## DEVELOPMENT APPLICATION ASSESSMENT REPORT

| <b>Application Number:</b> | DA2020/0028 |

| <b>Land to be developed (Address):</b>    | Lot 22 DP 11552, 9 Ocean Road PALM BEACH NSW 2108           |
| <b>Proposed Development:</b>              | Construction of a dwelling house                            |

Original terracing and retaining walls

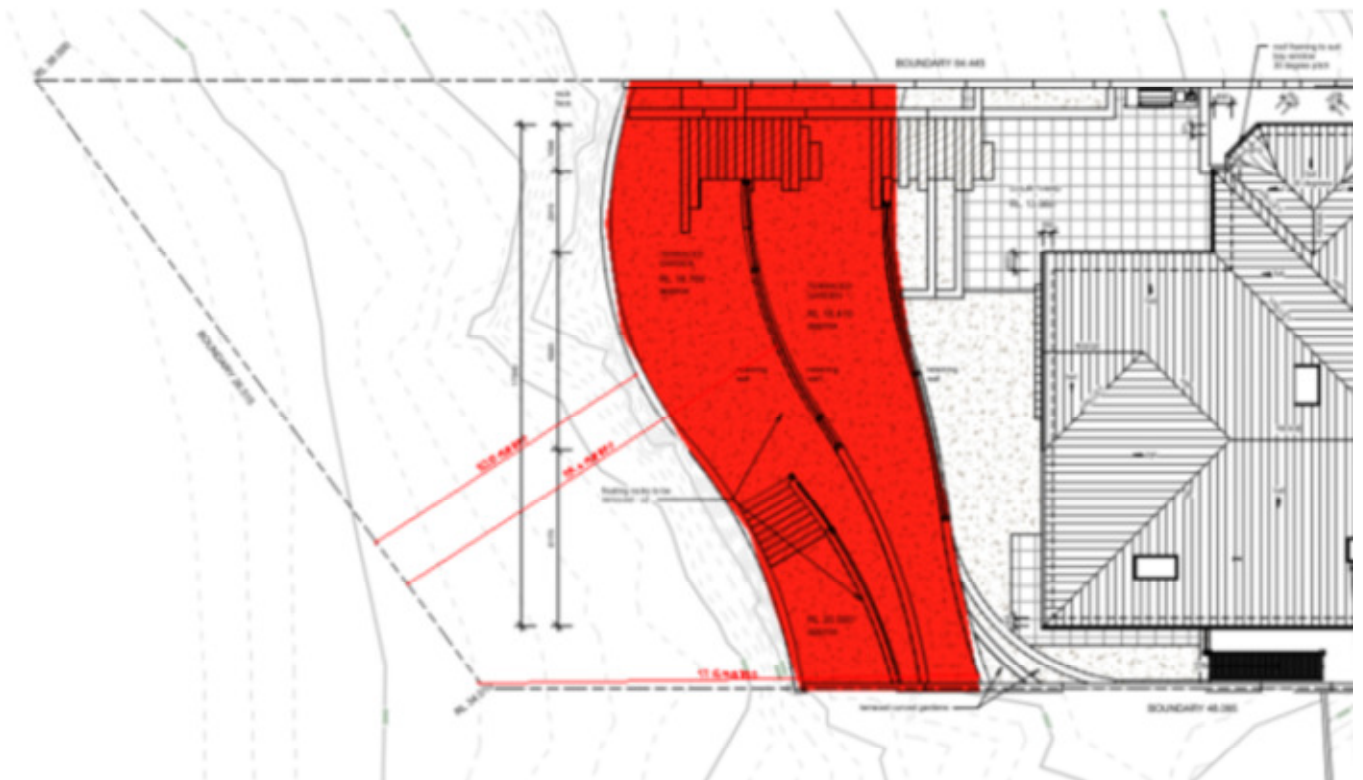
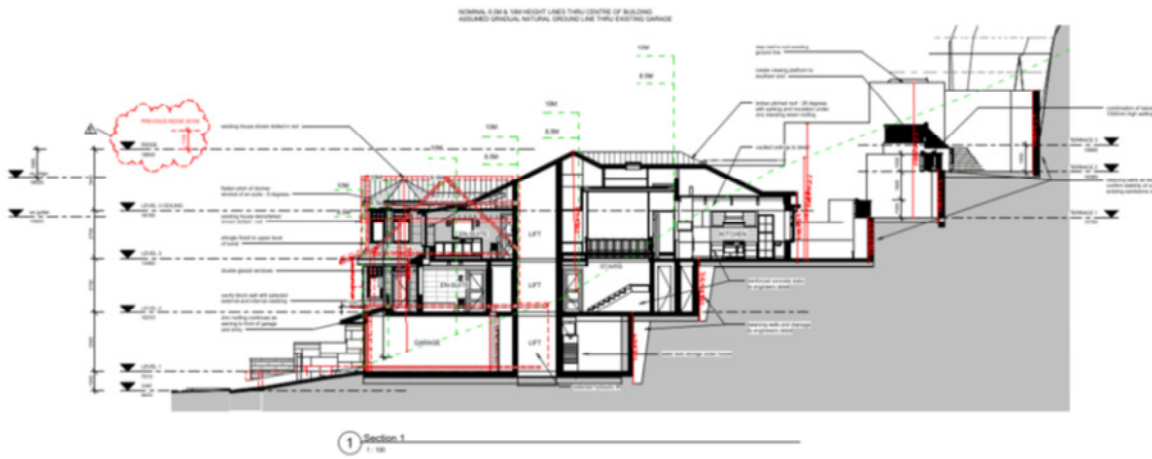
- Proposed excavation and visual impact of the required retaining structures
- Proposed drainage works;
- Pre and post construction dilapidation reporting and vibration monitoring;
- Setbacks of the building from the northern side boundary;
- Views from the proposed development been obstructed by future development at No, 8 Ocean Road

*"Whilst we appreciate that the level of excavation required to accommodate the actual dwelling*

Comment: Council acknowledges the issues raised within the submission. A formal request to the applicant was made by Council for substantial reductions of the terracing and retaining wall structures in the rear yard via the deletion of the upper two terraces which would reduce the visual dominance of the retaining walls structures to the street, public domain and address the relevant sections of the PLEP, PDCP, and the Coastal SEPP.

### Amended plans with reduced terracing and retaining walls

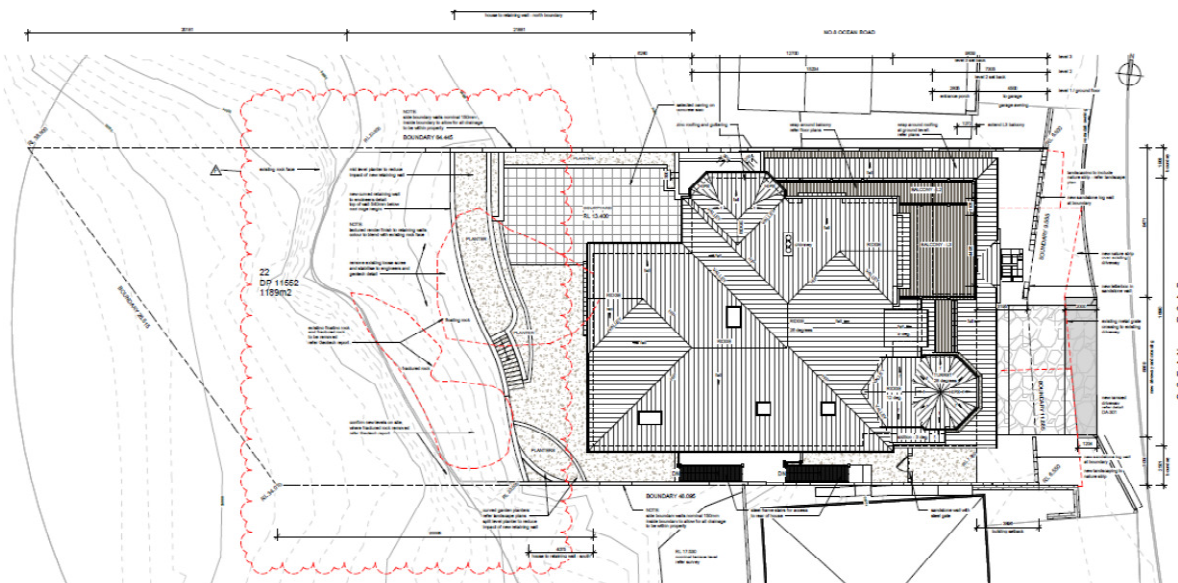
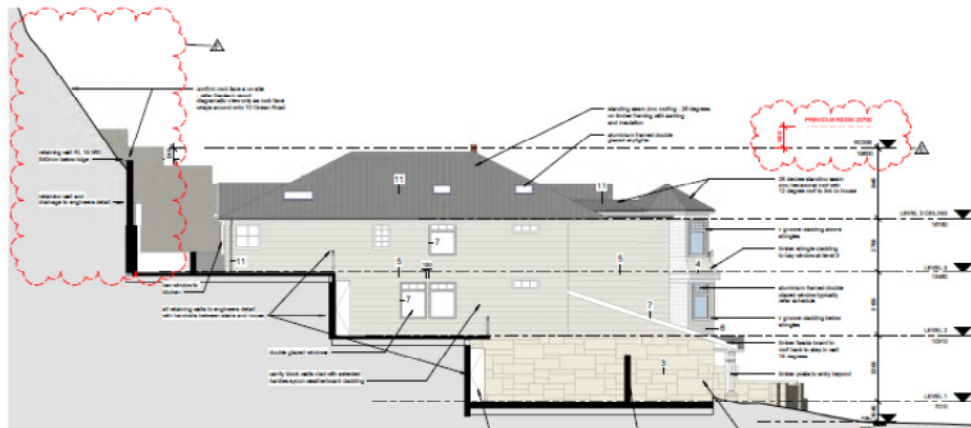
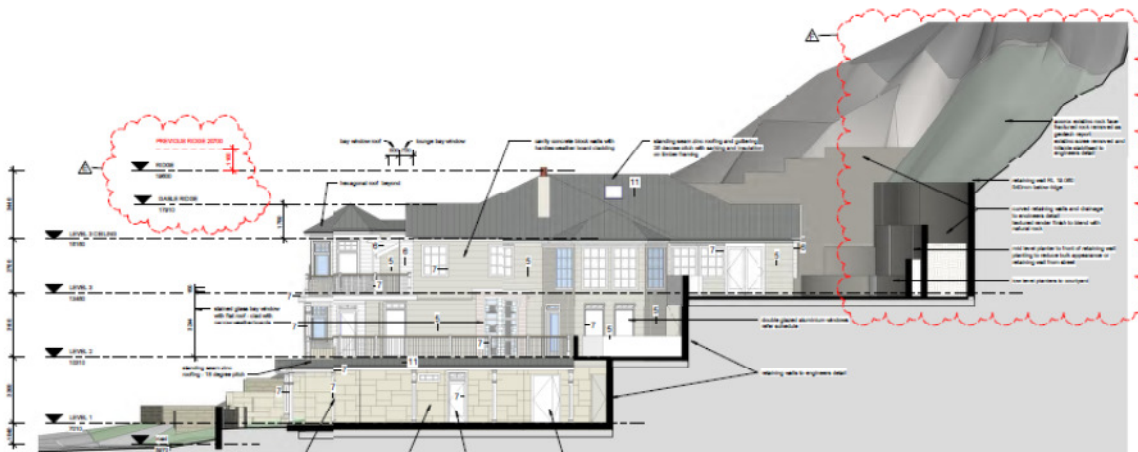
Amended plans were received. The amended plans (DA-001 through to DA-501 - Rev F dated 31 May 2020) have significantly reduced the area of the rear yard being excavated and retained and provided a resolution to the concerns raised within the submission. It is noted that the top of the rear retaining wall is now 540mm below the ridge height of the dwelling house. Comparative details below.

Given the above it is considered that issue has been addressed and does not warrant refusal or further amendment by condition(s).
